DART AEROSPACE LTD	Work Order:	97866
Description: Crosstube Assembly (205/212 High Aft)	Part Number:	D212-664-241
Inspection Dwg: D212-664-241 Rev: D		Page 1 of 2

DRAWING NO. D212-664-241	TITLE CROSSTUBE ASSY (205/212 HI AFT)	REV. D	DART AEROSPACE LTD ENGINEERING ORDER		D.E.O. NO. D212-664-241-D-1	SHEET NO. SHEET 1 OF 2	SCALE NTS
DRAWN	CHECKED	MFG. APPR.	APPROVED	DE APPR.			
DATE 11.04.07	DATE 11.04.11	DATE 11.04.12	DATE 11/04/12	DATE 11.04.12

DRAWING NO. D212-664-241	TITLE CROSSTUBE ASSY (205/212 HI AFT)	REV. D	DART AEROSPACE LTD ENGINEERING ORDER	D.E.O. NO. D212-664-241-D-1	SHEET NO. SHEET 2 OF 2	SCALE NTS
DRAWN	CHECKED <i>CP</i>	MFG. APPR. <i>E</i>	APPROVED <i>MD</i>	DE APPR. <i>MD</i>		
DATE 11.04.07	DATE 11.04.11	DATE 11.04.12	DATE 11/04/12	DATE 11.04.12

DRAWING NO. D212-664-241	TITLE CROSSTUBE ASS'Y (205/212 HI AFT)	REV. D	DART AEROSPACE LTD ENGINEERING ORDER	D.E.O. NO. D212-664-241-D-2	SHEET NO. SHEET 1 OF 1	SCALE NTS
DRAWN 97	CHECKED ASS	MFG. APPR. [Signature]	APPROVED [Signature]	DE APPR. [Signature]		
DATE 11.07.15	DATE 11.07.20	DATE 11.07.21	DATE 11/07/21	DATE 11.07.21

**D212-664-241/-241B
ASSEMBLY DETAIL**

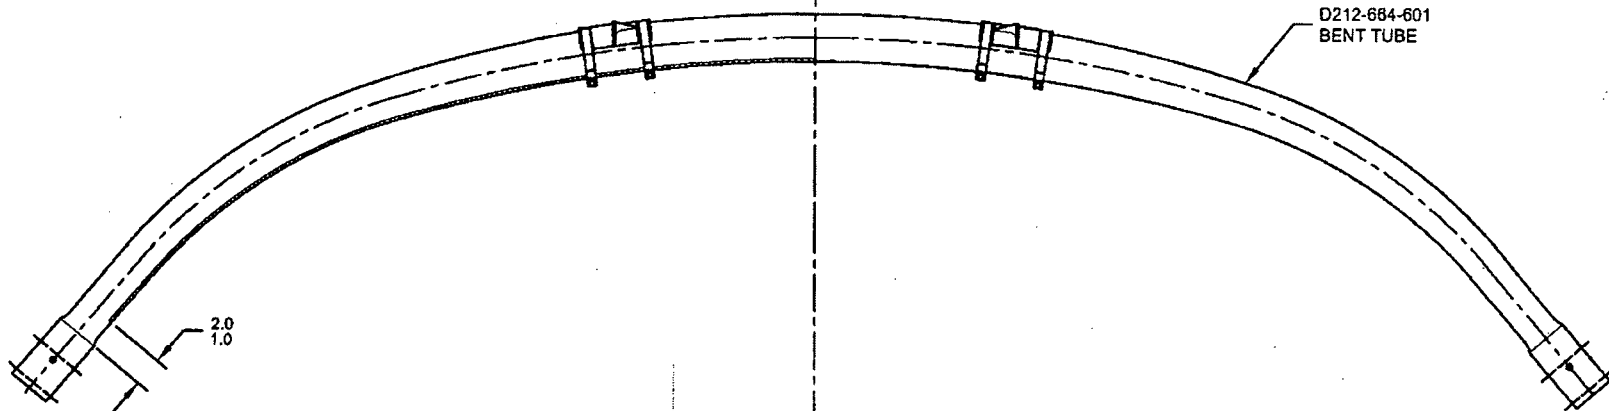
PURPOSE:

ADD AN INSPECTION WINDOW TO UNDERSIDE OF CROSSTUBE.

NOTES 2 OF SHEET 1 IS AMENDED AS FOLLOWS:

IS:

WAS:

- 2) FINISH: CHEMICAL CONVERSION COAT PER DART QSI 005 4.1
PRIME INSIDE AND OUTSIDE PER DART QSI 005 4.2
MASK UNDERSIDE OF CROSSTUBE AS SHOWN (HATCHED AREA) AND
PAINT OUTSIDE PER DART QSI 005 4.2
REMOVE MASKING AND APPLY CLEAR COAT

MASK AREA PRIOR TO PAINTING,
REMOVE MASKING AFTER PAINT
AND APPLY CLEAR COAT
